Western Springs shared path

Feedback report

Proposed Western Springs shared path

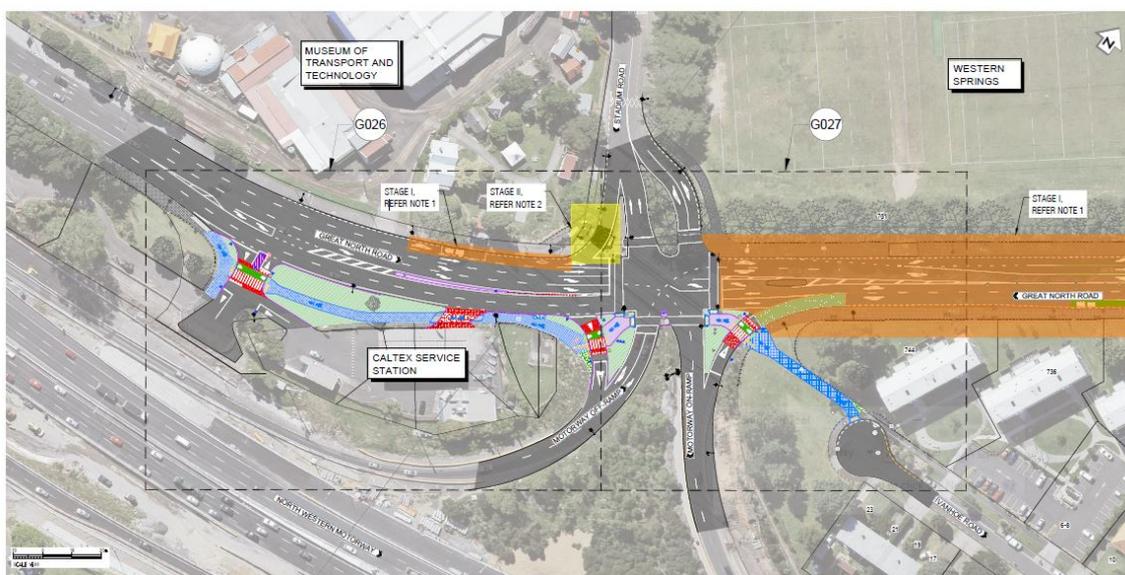
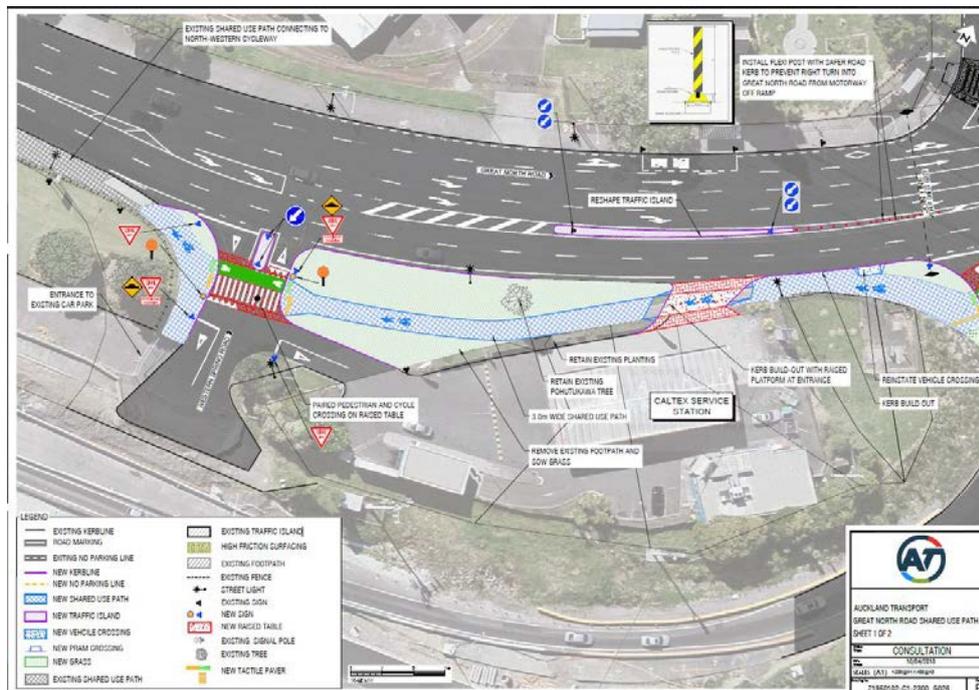
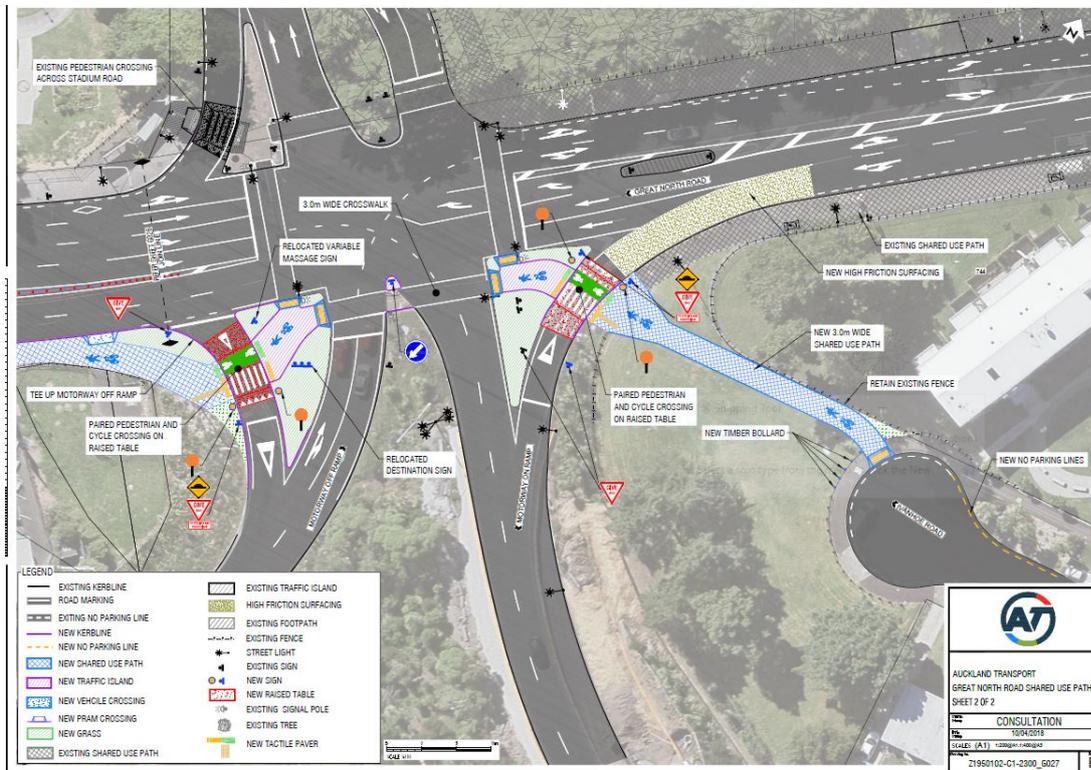
The Blind Foundation have concerns with some of the design elements. These are noted on the plans. In particular the zebra crossings shown in red and white. For people who have low vision or those who have loss of colour vision the colours may not be interpreted as meaning a zebra crossing.

We recommend that the section of the road that the pedestrians use remains the understood and more visual black and white colours. There may also be issues for those who have cognitive impairments - including those who have brain injury i.e. from strokes. The change of colour of the path at the Caltex Service Station could also be an issue so we recommend the path remains the same colour and the approaches for vehicles different.

There are also additional directional TGSi required for an indented crossing. Within the islands (as shown drawn) there is potential for pedestrians who are blind or have low vision to walk to the cycle crossing section. This needs to be understood and communicated to cyclists - why have they been separated - the path is shared. The rest of the path is not defined in this way.

Feedback by theme	AT Responses
<p>Pedestrian Safety</p> <p>The Blind Foundation have concerns with some of the design elements. These are noted on the plans.</p> <p>In particular the zebra crossings shown in red and white. For people who have low vision or those who have loss of colour vision the colours may not be interpreted as meaning a zebra crossing. We recommend that the section of the road that the pedestrians use remains the understood and more visual black and white colours.</p> <p>There may also be issues for those who have cognitive impairments - including those who have brain injury i.e. from strokes. The change of colour of the path at the Caltex Service Station could also be an issue so we recommend the path remains the same colour and the approaches for vehicles different.</p> <p>There are also additional directional tgsi required for an indented crossing. Within the islands there is potential for pedestrians who are blind or have low vision to walk to the cycle crossing section. This needs to be understood and communicated to cyclists - why have they been separated - the path is shared. The rest of the path is not defined in this way.</p>	<p>Thank you for your feedback. See engineer responses below:</p> <ul style="list-style-type: none"> • Zebra crossings will be black and white, following national standards for zebra crossings. The red colour on the drawings reflects the new raised table for illustration purposes, and doesn't reflect the colour of the surface. • The colour of the path will be white, the same as a standard shared path on section where it crosses the Caltex service station entrance. Red is only there in the drawing to show a new raised table, but does not reflect the colour of the surface. • We agree it would make sense to have the crossing one shared space. However, Traffic Control Devices (TCD) rule amendments requires a pedestrian/cyclist priority crossing to be designed as shown with pedestrians and cyclists separated. In order for the facility to carry legal status as a priority crossing, they need to be designed in accordance to these national standards.
